Subject: MHI's Response to US-APWR DCD RAI No. 251-2146 REVISION 1

Reference: 1) "Request for Additional Information No.251-2146 Revision 1, SRP Section: 10.04.08 - Steam Generator Blowdown System, Application Section: 10.4.8" dates March 2, 2009.

Response to Request for Additional Information
No. 251-2146 Revision 1

US-APWR Design Certification
Mitsubishi Heavy Industries
Docket No. 52-021

Fig10.4.8-3. Concept of Peripheral Blowdown

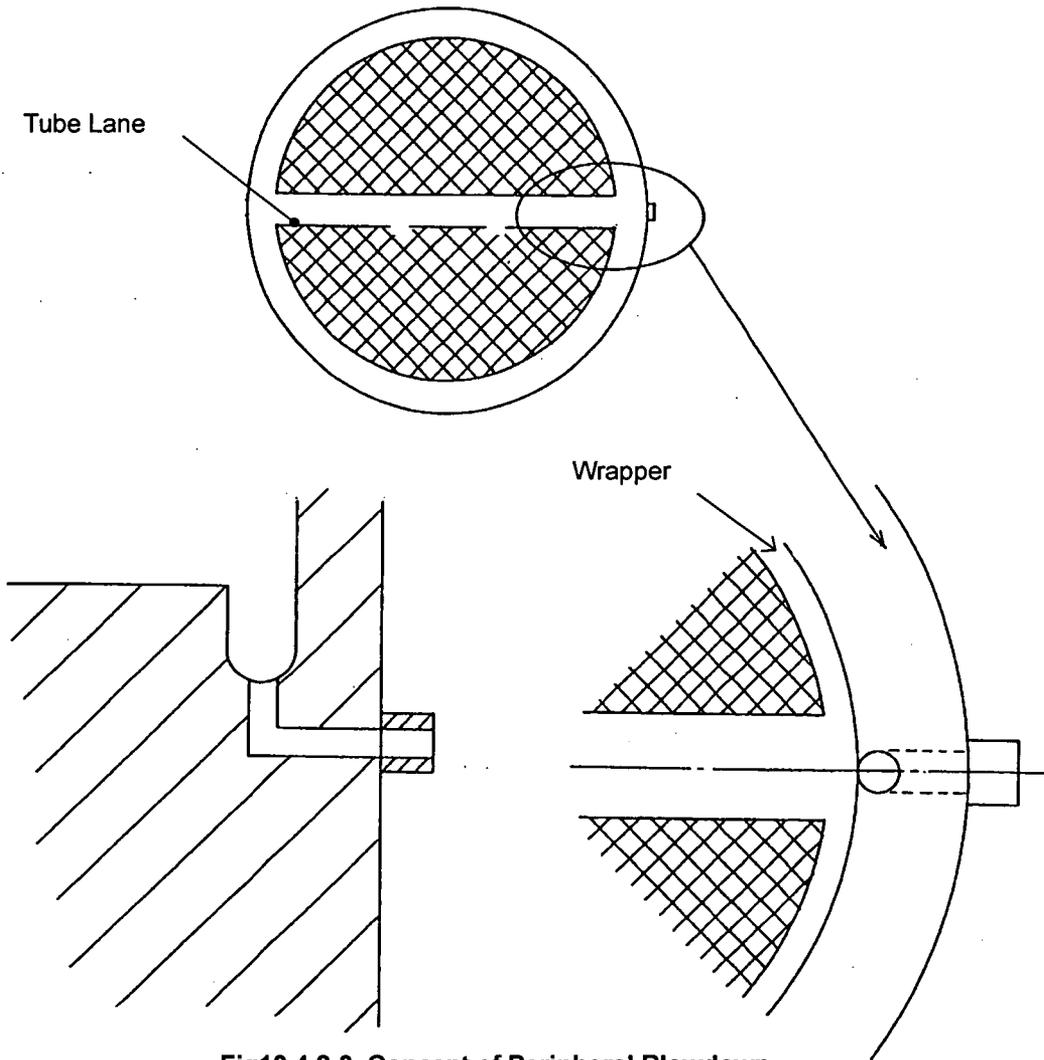
Please provide more specific detailed information about the location of the blowdown nozzle and include it in the DCD. Discuss the basis (e.g., operating experience) for selecting the specified location. The staff did not find the location indicated on a drawing, and the DCD (Tier 2, page 10.4-63) describes it only in general terms ("a location above the tube sheet of each steam generator where impurities are expected to accumulate").

MHI will add the description of the location of the blowdown nozzle. DCD Tier 2 Chapter 10 Subsection 10.4.8.2.1 will be updated to modify the description SG blowdown nozzle and add the new drawing of SG blowdown nozzle as Figure 10.4.8-3. The DCD will be revised to add a description as shown in "Impact on DCD" below.

The US-APWR SG's utilize a "peripheral" blowdown system arrangement. In this arrangement, blowdown holes are drilled from approximately 7 inches below the secondary surface of the tubesheet and intersect with the peripheral groove on the secondary face of the tubesheet. This arrangement is shown as Figure 10.4.8-3 and facilitates effective sludge removal from the tubesheet.
